# Access Compliance Report

## Public Rights-of-Way

Intersection ID: 12811	Main Street: SCHOOL_ST	Cross Street: THOMAS_AV	Location: NE
ADA ID: 7E06E4B031CC	Ramp Type: PerpDiag	Initial Pass/Fail: Fail	Overall Compliance: No
		Severity Score: 8.75

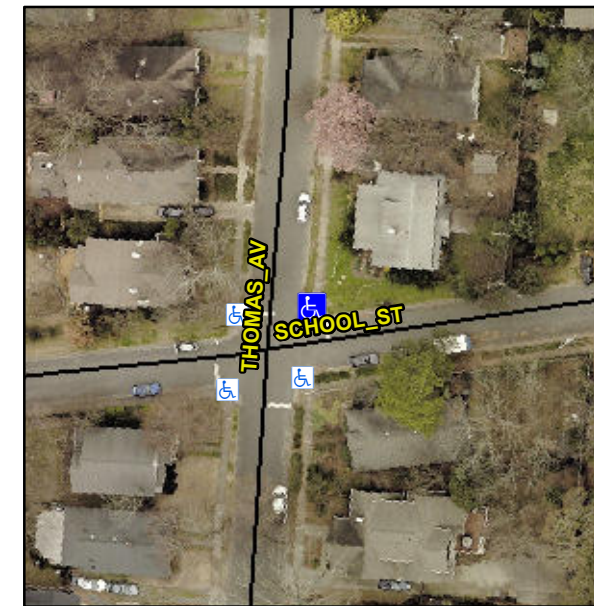
**Not Found, R304.5.1**

Compliance	Description	Data	Compliance	Description	Data
N/A	Ramp Length (in)	45.0	Yes	Ramp Slope (%)	7.0
No	Ramp Width (in)	42.0	Yes	Ramp XSlope (%)	1.8
N/A	Flare Type LT	N/A	N/A	Flare Type RT	N/A
N/A	Flare Slope LT (%)	N/A	N/A	Flare Slope RT (%)	N/A
N/A	Flare Traversable LT?	N/A	N/A	Flare Traversable RT?	N/A
N/A	Landing Length (in)	N/A	N/A	DWS Provided?	N/A
N/A	Landing Width (in)	N/A	N/A	DWS Contrast?	N/A
N/A	Landing Slope (%)	N/A	N/A	DWS Length (in)	N/A
N/A	Landing X Slope (%)	N/A	N/A	DWS Full Width?	N/A
N/A	Landing Curb? (Y/N)	N/A	N/A	DWS Offset (in)	N/A
N/A	Shared Landing?	N/A			
N/A	Gutter Ponding?	N/A	N/A	Gutter Slope (%)	N/A
N/A	Gutter Lip Ht (in)	N/A	N/A	Gutter X Slope (%)	N/A
N/A	Painted X Walk1?	No	N/A	Painted X Walk2?	No
	X Walk 1 Direction	To W		X Walk 2 Direction	To S
N/A	X Walk 1 Width (in)	N/A	N/A	X Walk 2 Width (in)	N/A
	X Walk 1 Slope (%)	2.8		X Walk 2 Slope (%)	6.2
	X Walk 1 X Slope (%)	5.3		X Walk 2 X Slope (%)	0.3

**Remove & Replace Curb Ramp With Two New Directional Ramps or Equivalent.**
